The 55 details drawn differently in CAD and Revit

Checked against the new drafters' file, 26 October.

55 of the 190 CAD typical details have a Revit version in your templates that is drawn differently. Each page: your CAD detail on the left, the Revit version on the right, what differs, and one answer: CAD is right, Revit is newer (we update CAD from it), or both wrong.

CAD: KOR-D201-DET 01 - TYPICAL DETAIL AT JUNCTION OF 60 TO 36 DEEP RAFT

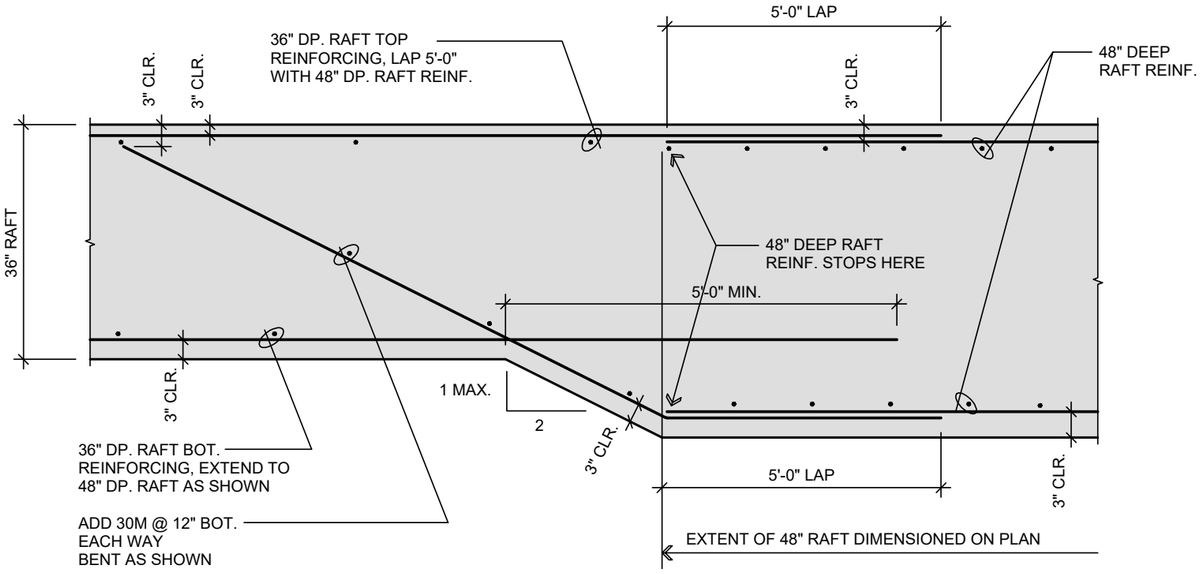
What differs: 60-to-36 junction version: same sloped transition but extra top-bar extension and 60-in raft reinforcing callouts; 'D2.01_1_TYPICAL CHANGE IN RAFT SLAB THICKNESS' is the generic change in thickness.

CAD: KOR-D201-DET 02 - TYPICAL DETAIL AT JUNCTION OF 48 TO 36 DEEP RAFT

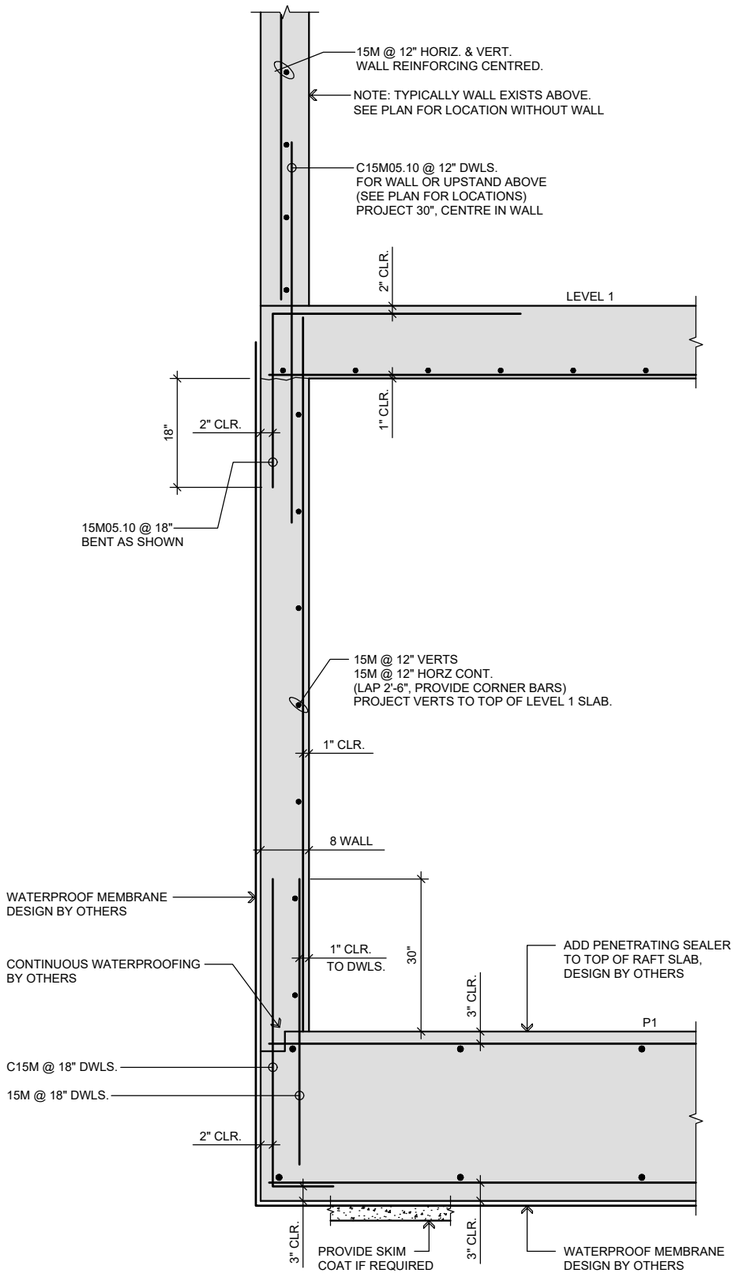
What differs: 48-to-36 junction version of the sloped raft transition; adds 48-in deep reinf callouts and a 30M bent bottom bar vs generic 'D2.01_1_TYPICAL CHANGE IN RAFT SLAB THICKNESS'.

CAD: KOR-D201-DET 03 - TYPICAL BASEMENT WALL

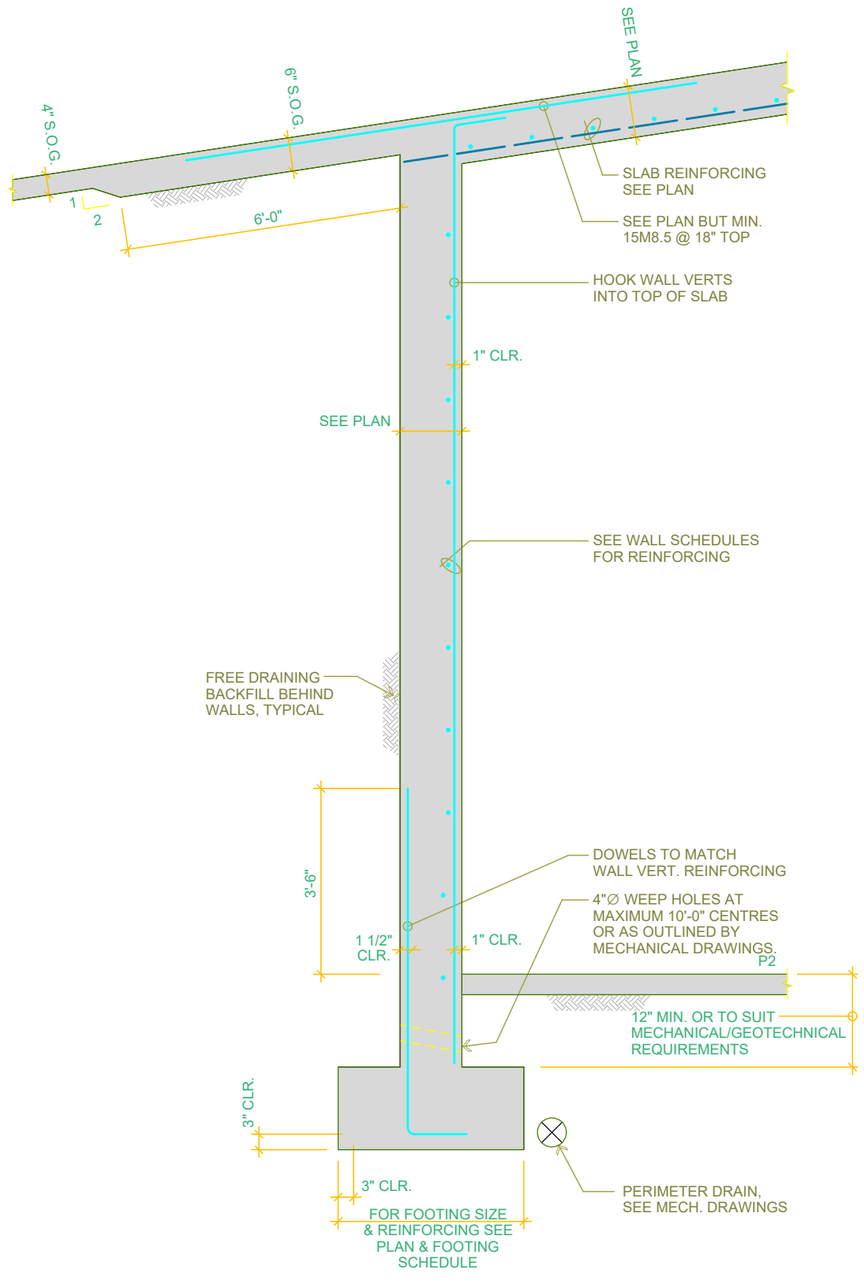
What differs: CAD is a basement wall running from suspended slab down into the raft with an intermediate slab; 'S5.05_1_BASEMENT WALL DETAIL' is a wall with sloped slab over and strip footing.

Revit: D5.01_1_TRENCH DRAIN ON GRADE DETAIL (Typical Details - Container_R23 (Need_MET & IMP).rvt; on D5.01 Series 5 Miscellan)

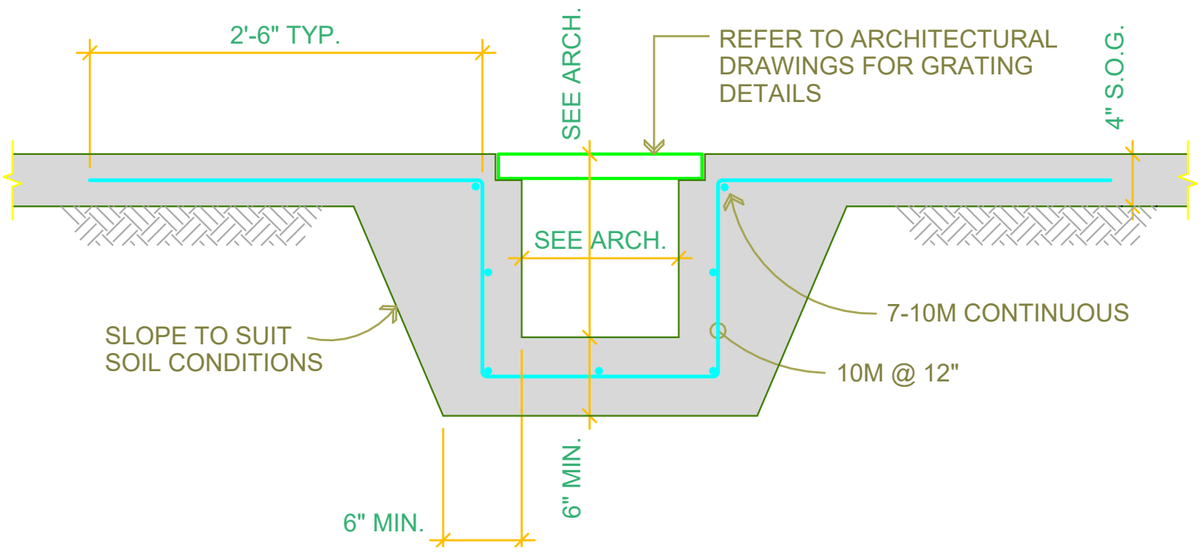
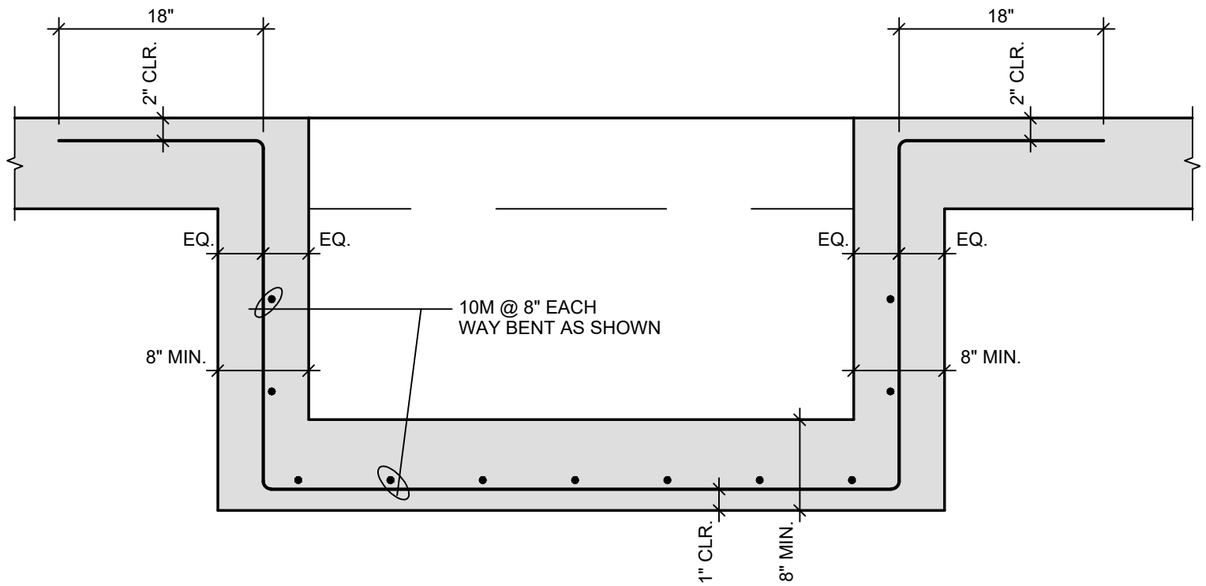
What differs: CAD is a trench drain in a thickened raft with 20M bars; 'D5.01_1_TRENCH DRAIN ON GRADE DETAIL' is the on-grade thickened trench of the same shape but different slab and bars ('D5.01_2_TRENCH DRAIN ON RAFT DETAIL' is a topping-on-raft trench).

CAD: KOR-D201-DET 11 - TYPICAL PIT IN STRUCTURAL SLAB

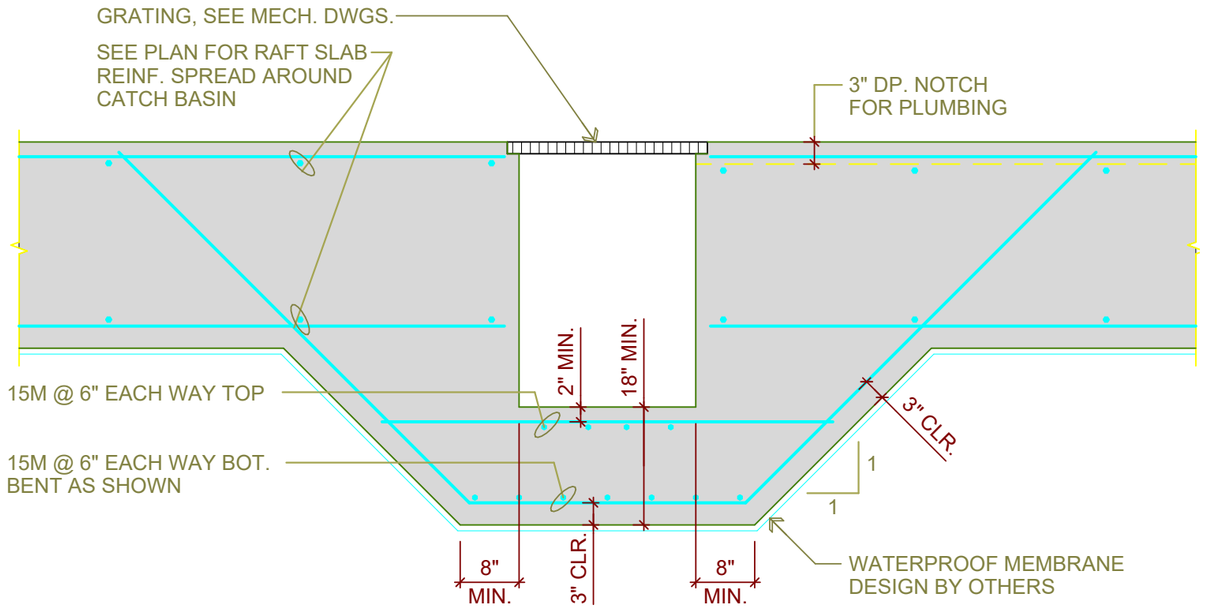
What differs: CAD is a square-sided pit dropped into a structural slab with 10M bent bars; 'D2.01_3_TYPICAL DETAIL AT CATCH BASIN OR SUMP IN RAFT SLAB' is a sloped-sided catch basin sump in raft - same purpose class, different shape and bars.

CAD: KOR-D201-DET 13 - SLOPE BETWEEN SLAB THICKNESS TYPICAL UNO

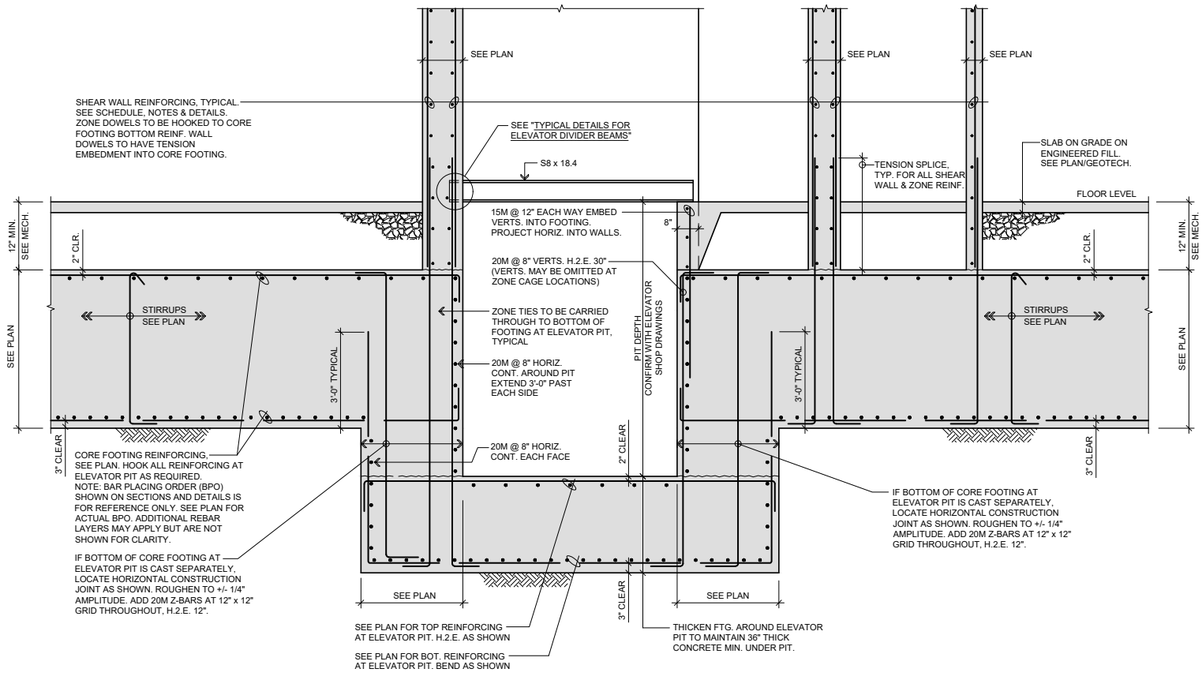
What differs: CAD slope between slab thicknesses has stirrups and tension laps on both layers; 'D2.01_1_TYPICAL CHANGE IN RAFT SLAB THICKNESS' shows a simpler bar arrangement.

CAD: KOR-D202-DET 03 - TYPICAL SECTION THRU CORE FOOTING AT ELEVATOR PIT

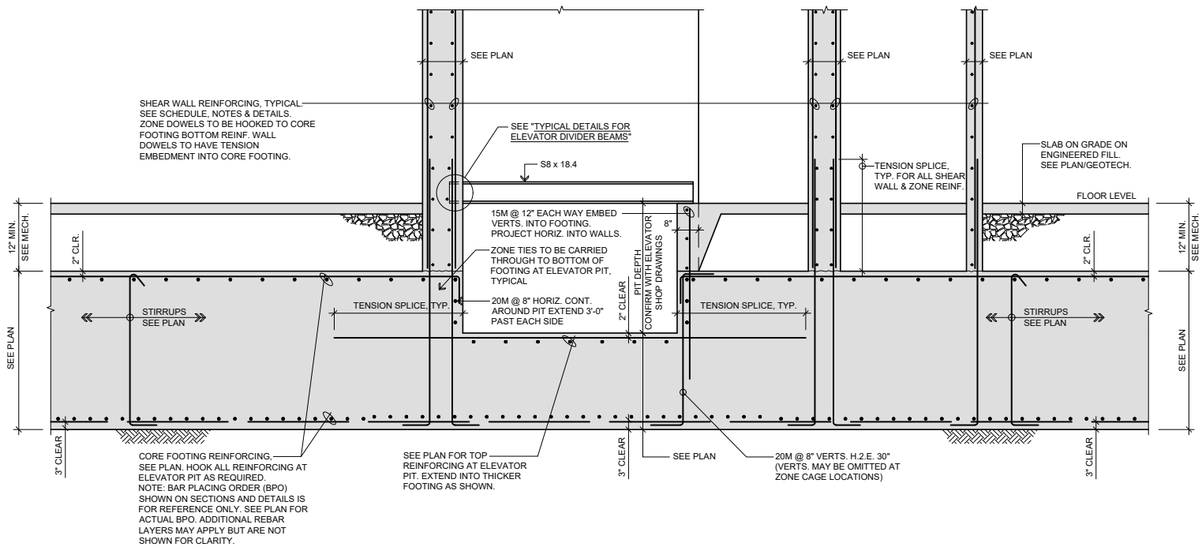
What differs: Core footing at elevator pit variant: flat footing with thicker pit slab, fewer callouts than 'S6.01_2_CORE FOOTING SECTION THRU ELEVATOR PIT'.

CAD: KOR-D202-DET 07 - TYPICAL SECTION THRU CORE FOOTING AT ELEVATOR PIT

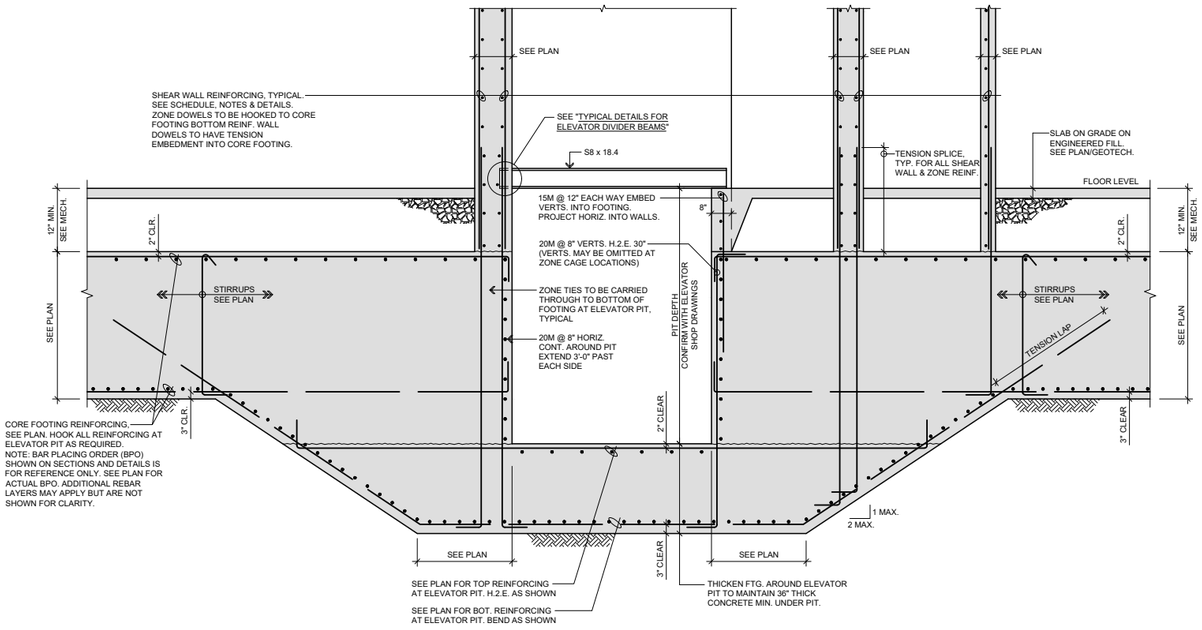
What differs: Core footing with sloped (haunched) sides to the deeper pit; 'S6.01_2_CORE FOOTING SECTION THRU ELEVATOR PIT' has vertical steps.

CAD: KOR-D301-DET 02 - BASEMENT WALL SECTION

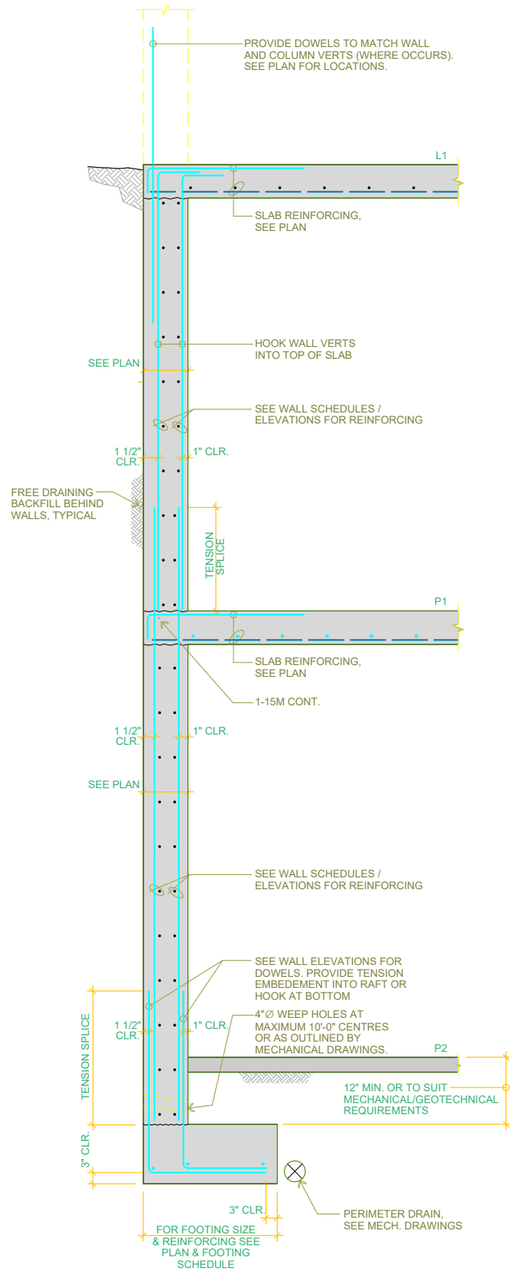
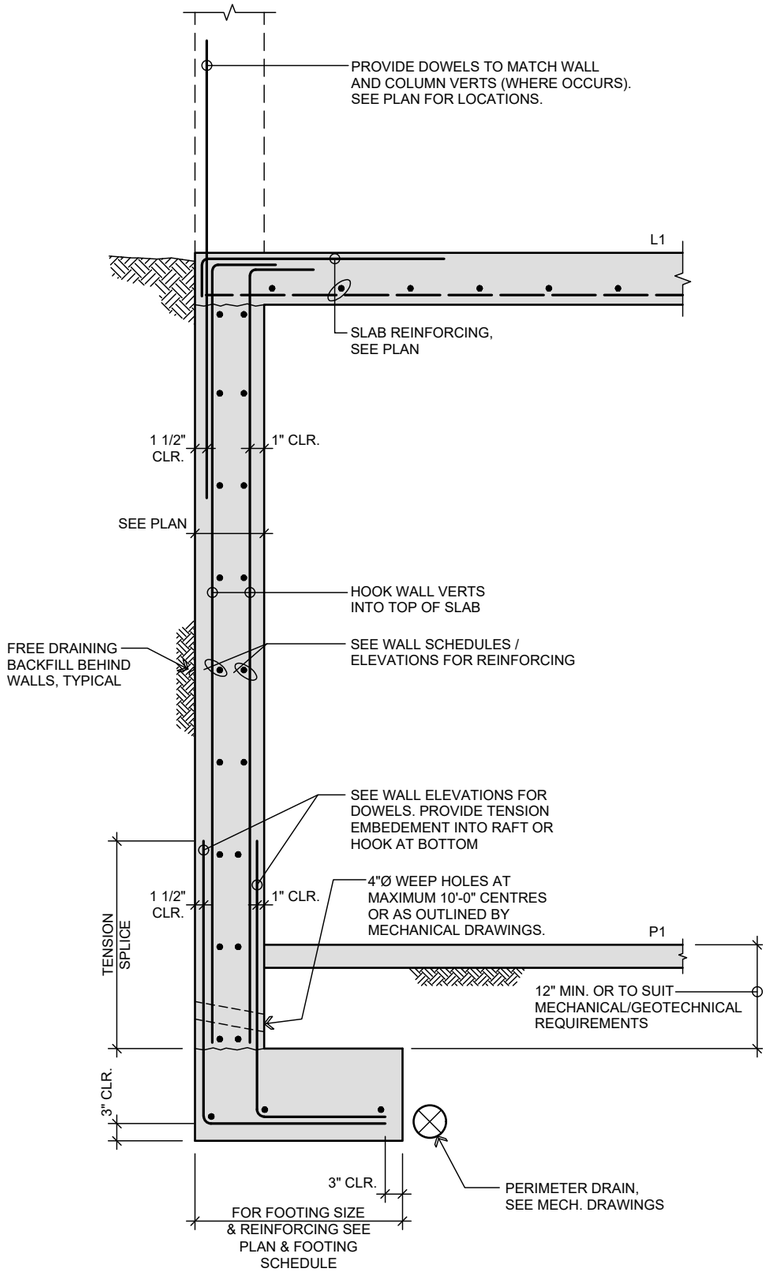
What differs: Same basement wall section but adds a wall-reinforcing-per-schedule callout and 15M bent bars that 'D3.01_1_BASEMENT WALL SECTION' lacks.

CAD: KOR-D301-DET 03 - BASEMENT WALL SECTION

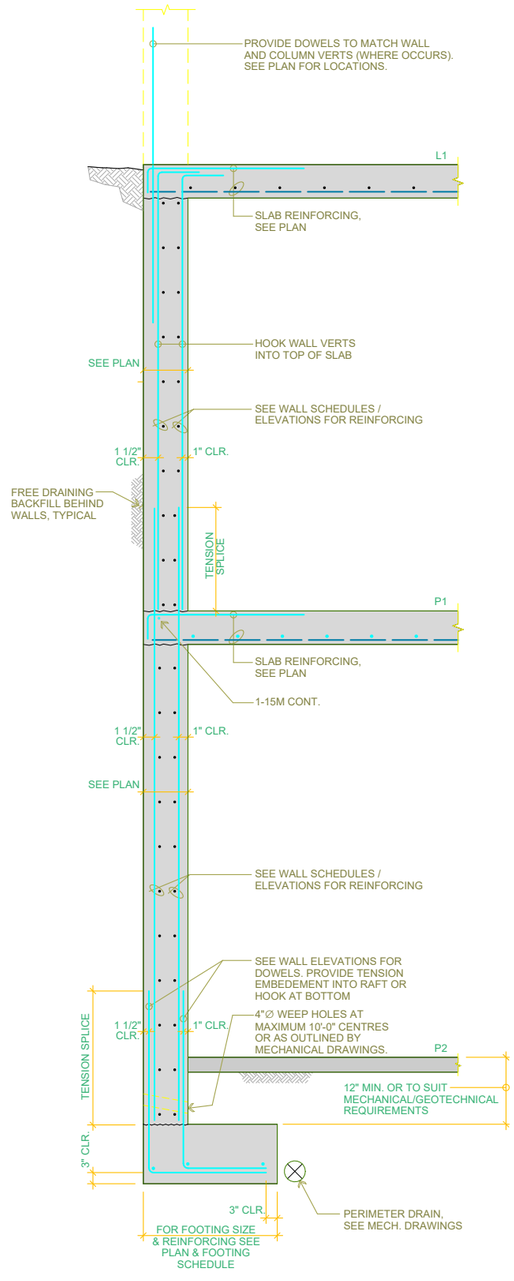
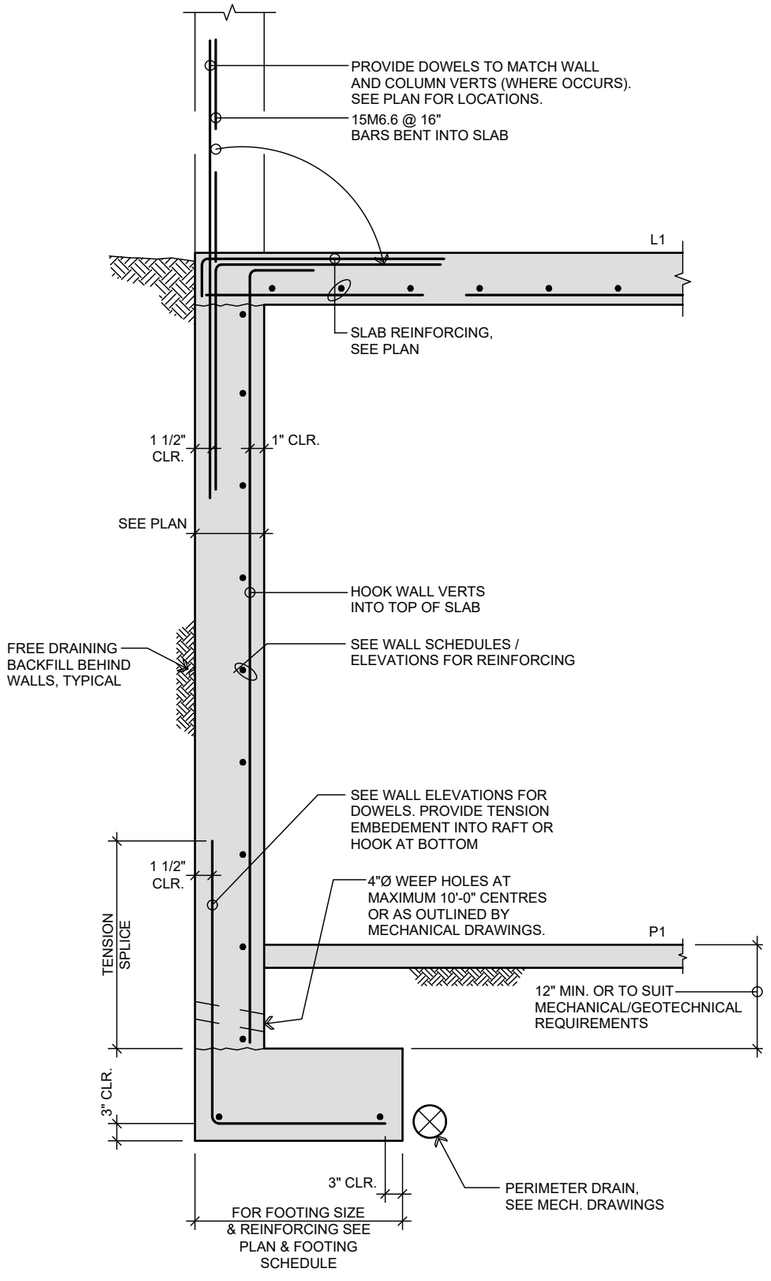
What differs: Single-storey basement wall with one slab and strip footing; 'D3.01_1_BASEMENT WALL SECTION' shows three suspended levels.
